ITEM: 6.3	COMMITTEE OF ADJUSTMENT REPORT SUMMARY MINOR VARIANCE APPLICATION FILE NUMBER A147/23 16 OBAN AVENUE, MAPLE
------------------	--

**COMMITTEE OF ADJUSTMENT REPORT
MINOR VARIANCE APPLICATION
A147/23
16 OBAN AVENUE, MAPLE**

ITEM NUMBER: 6.3	CITY WARD #: 1
APPLICANT:	Slavka & Zoran Kapor
AGENT:	Gama Engineering Inc.
PROPERTY:	16 Oban Avenue, Maple
ZONING DESIGNATION:	See below.
VAUGHAN OFFICIAL PLAN (2010) DESIGNATION:	Vaughan Official Plan 2010 ('VOP 2010'): "Low-Rise Residential"
RELATED DEVELOPMENT APPLICATIONS:	None
PURPOSE OF APPLICATION:	Relief from the Zoning By-law is being requested to permit an addition to the existing dwelling (located on existing deck), two proposed residential accessory structures (sheds) to be located in the rear yard and an existing shed located in the exterior side yard.

TITLE:
 PROPOSED SHED PLAN & ELEVATION
 ROOF FRAMING PLAN AND ELEVATIONS

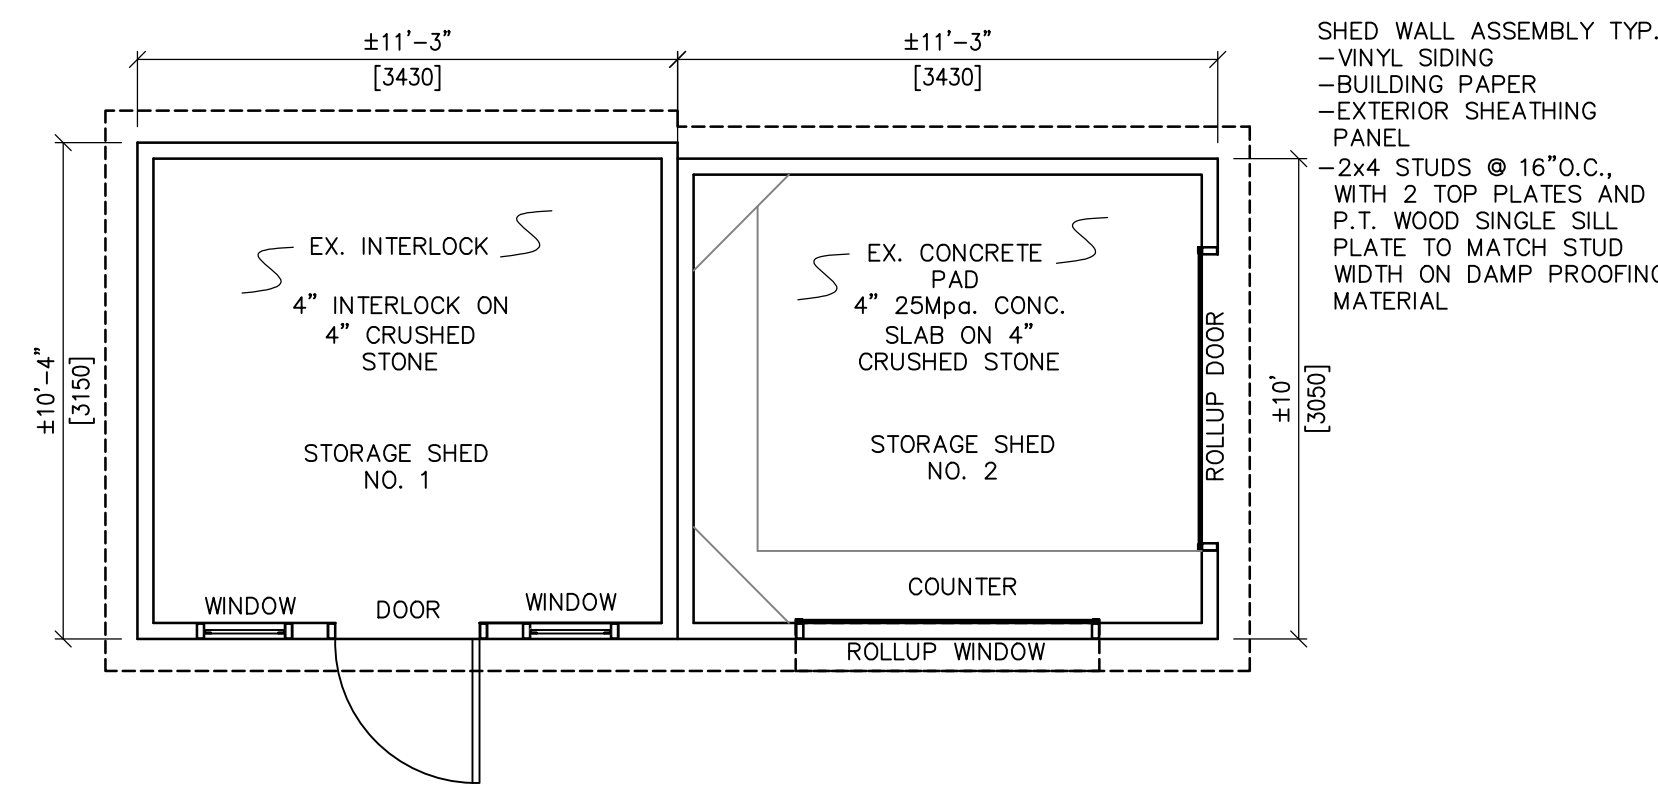
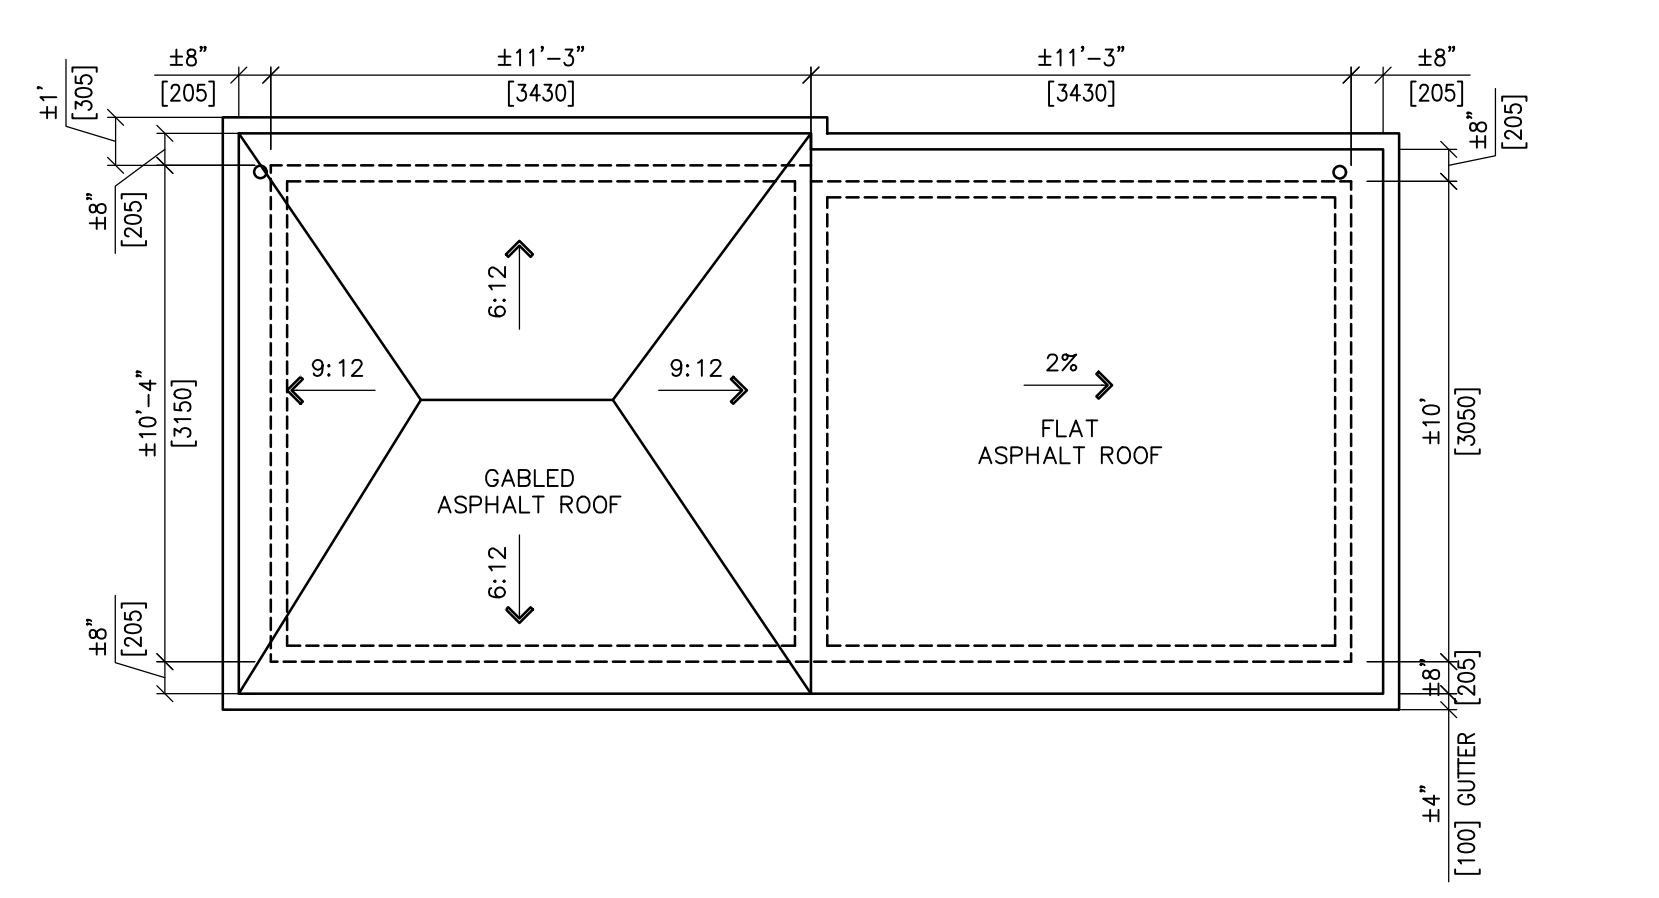
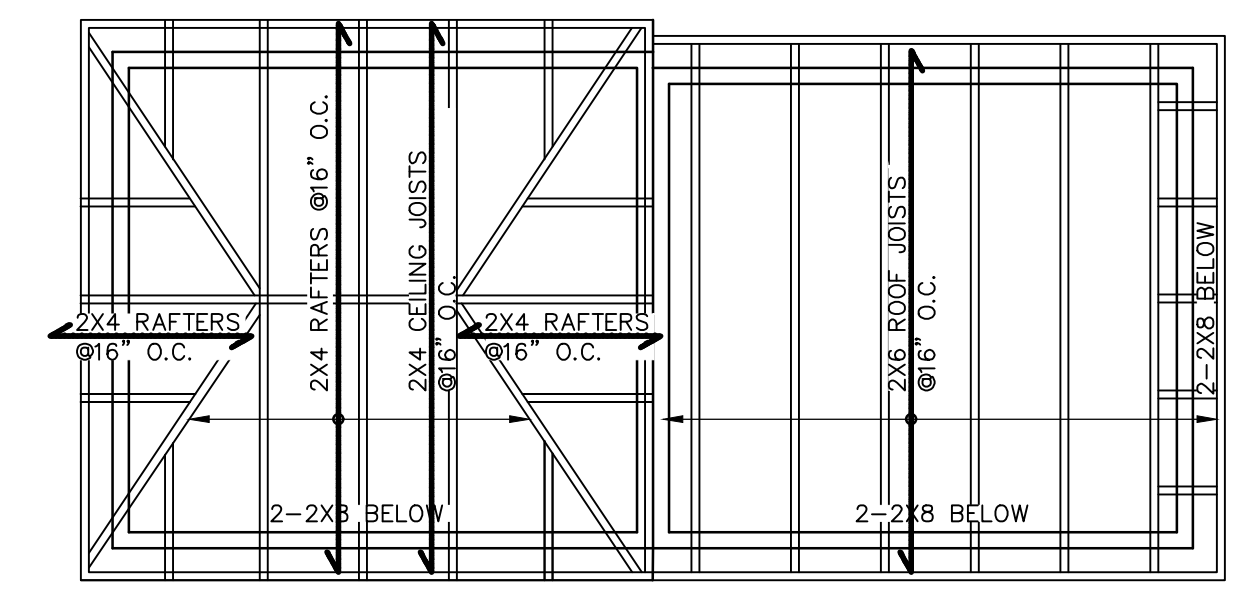
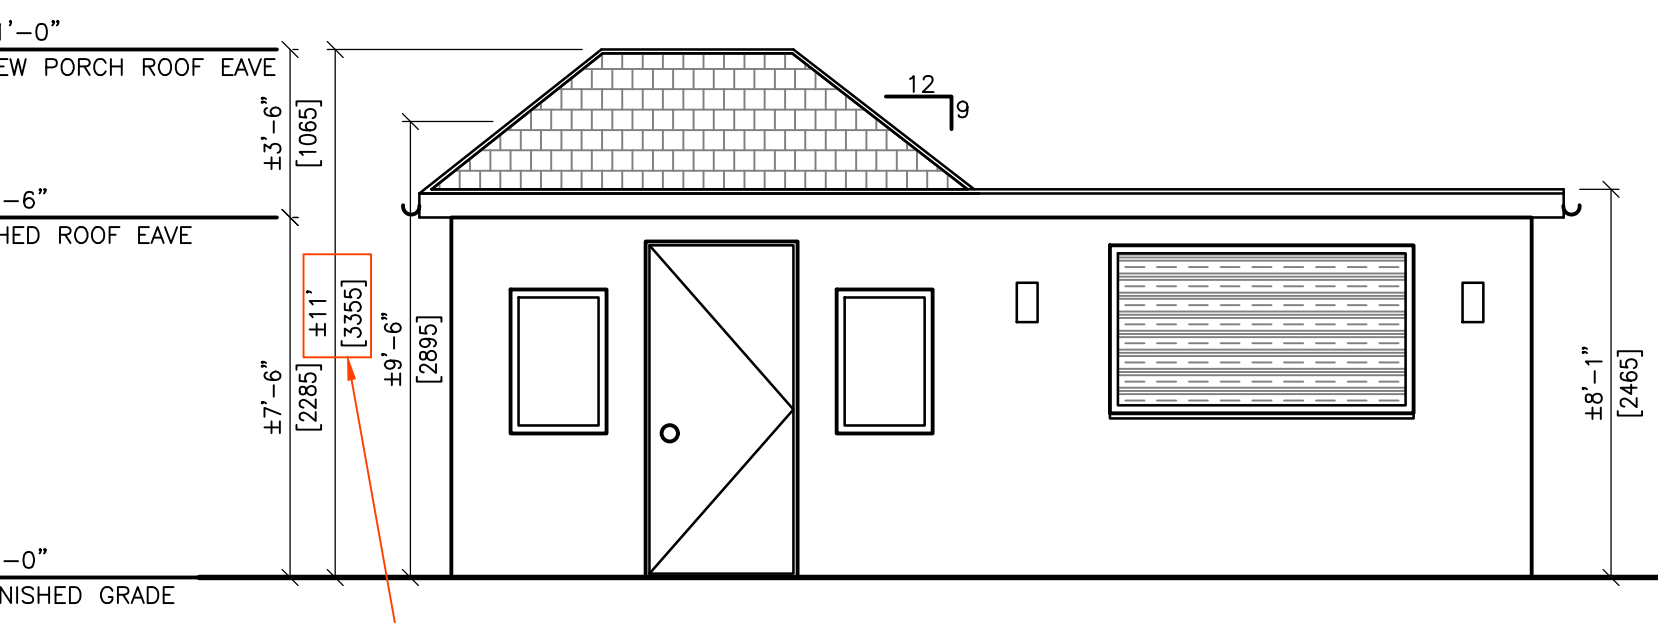
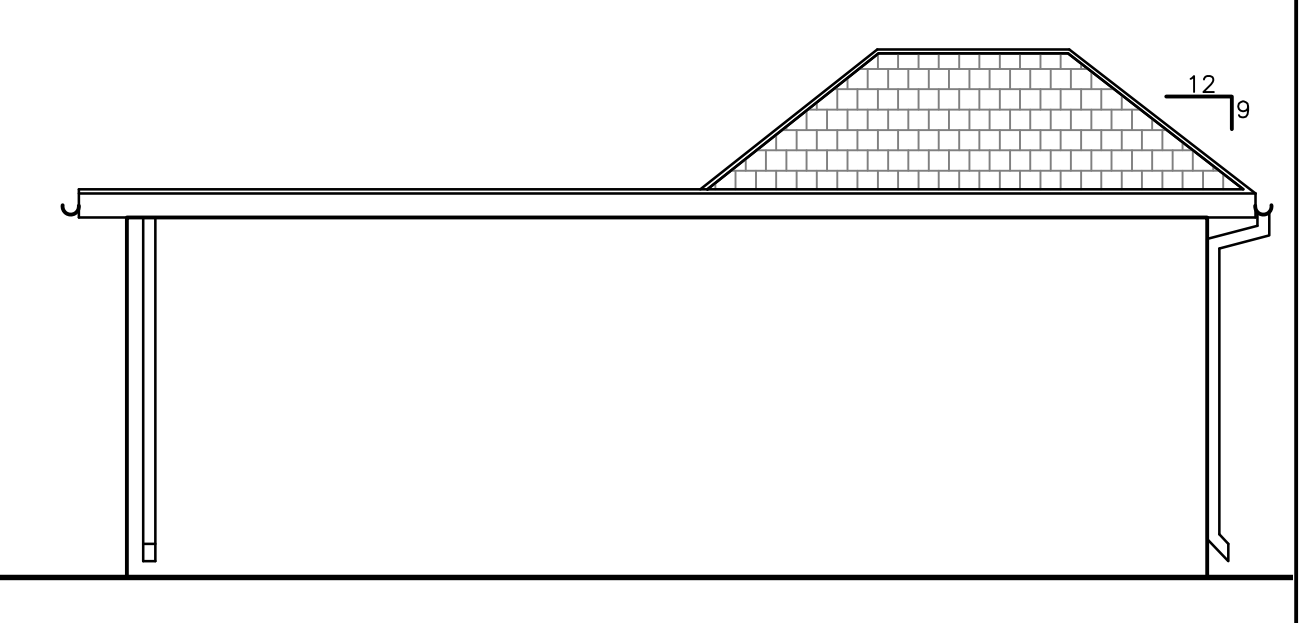
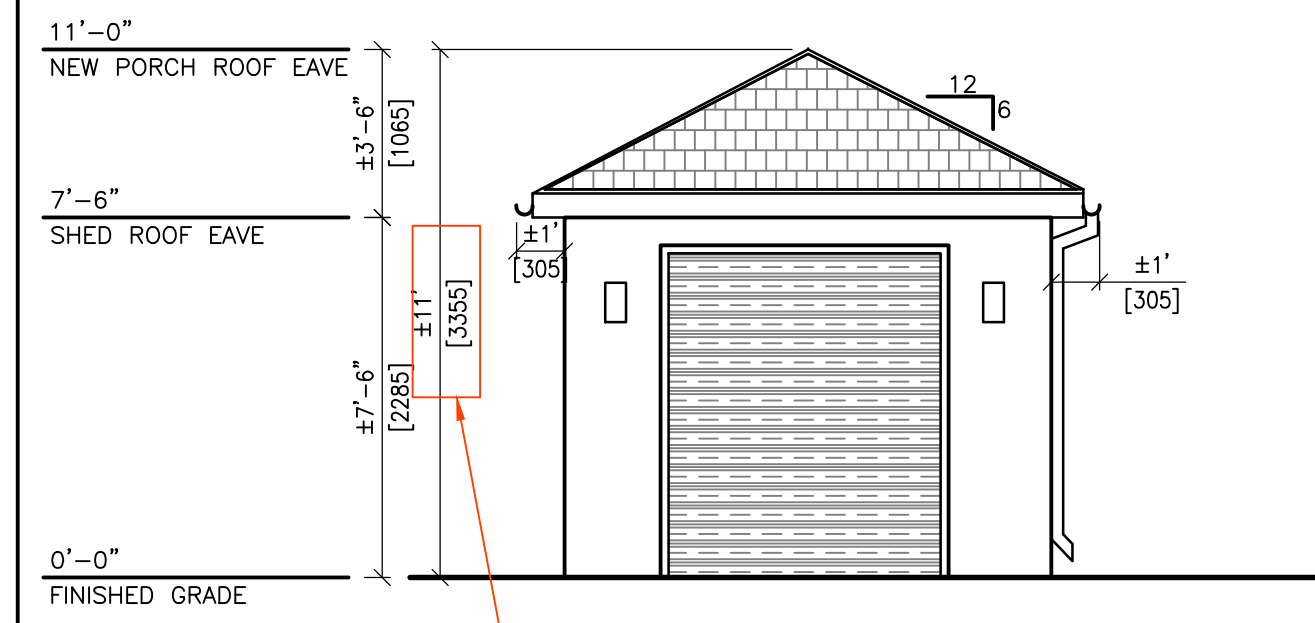
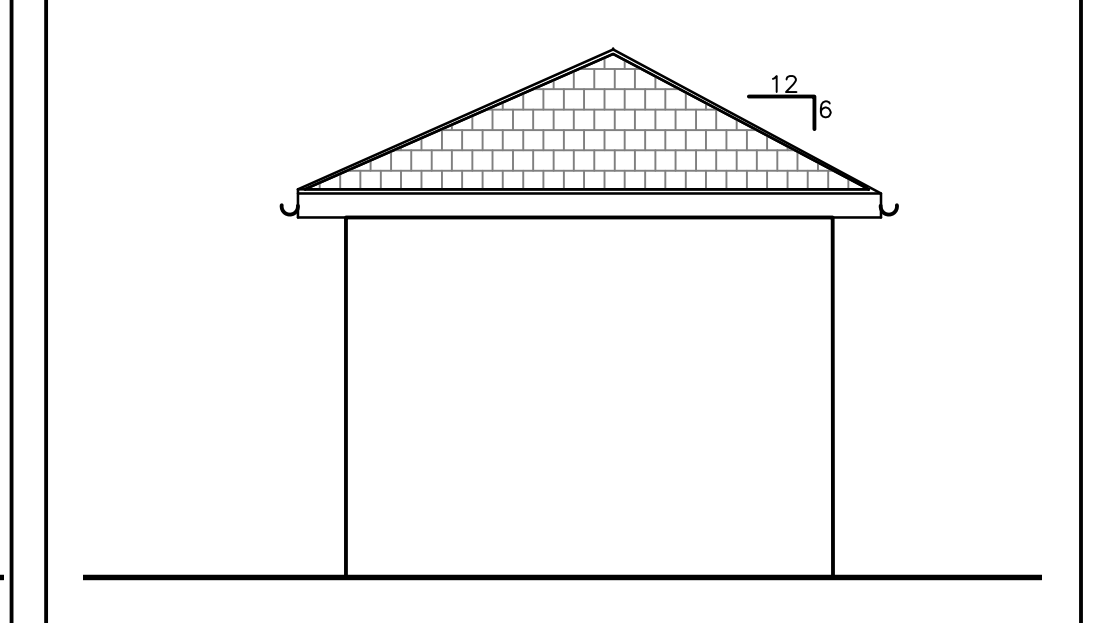
Development Planning Department cannot support the portion of Variance 1 that applies to the location of the double shed as proposed. Also, the Development Planning Department is not in a position to support Variances 2 and 4 for the height and reduced rear and exterior side yard setbacks for the residential accessory structure (double shed). While Development Engineering has reviewed the above noted variances and has no concerns with the reduced rear and exterior side yard setbacks for the double shed from a lot grading and drainage perspective, Development Planning is of the opinion that its placement so close to the rear and exterior lot lines in combination with its height, is not appropriate. The abutting neighbour to the north, 36 Oban Avenue, shares their interior side lot line with 16 Oban Avenue's rear lot line. The proposed double shed abuts the front yard of 36 Oban Avenue. When viewed from Oban Avenue, the double shed presents a continuous stretch of built form spanning the entire depth of the front yard of 36 Oban Avenue. The shed projects some distance above the privacy fence, resulting in the structure being visually prominent with respect to the streetscape.

Development Planning is of the opinion that a 0.76 m rear yard setback, resulting in a 1.64 m reduction, is not minor in nature and will result in significant massing and character implications along the rear and exterior lot line and existing streetscape. The double shed presents a long stretch of continuous built form abutting the front yard of 36 Oban Avenue when viewed from the street. The Development Planning Department is of the opinion that the distance between the double shed and exterior and rear property lines is not sufficient to provide adequate spatial separation or allow for the establishment of screening vegetation. As such, the Development Planning Department is not in a position to support Variances 2 and 4.

Accordingly, the Development Planning Department is not in a position to support part of Variance 1 for the double shed and Variances 2, 3, and 4 for the height and reduced setback of the double shed and for the reduced rear yard setback to the existing addition. The Development Planning Department is of the opinion that the proposal is not minor in nature, does not maintain the general intent and purpose of the Official Plan and Zoning By-law, and is not desirable for the appropriate development of the land.

The Development Planning Department recommends **refusal** of the part of Variance 1 pertaining to the double shed and Variances 2, and 4, and **approval** of the part of Variance 1 pertaining to the single shed, Variance 3 and 5.
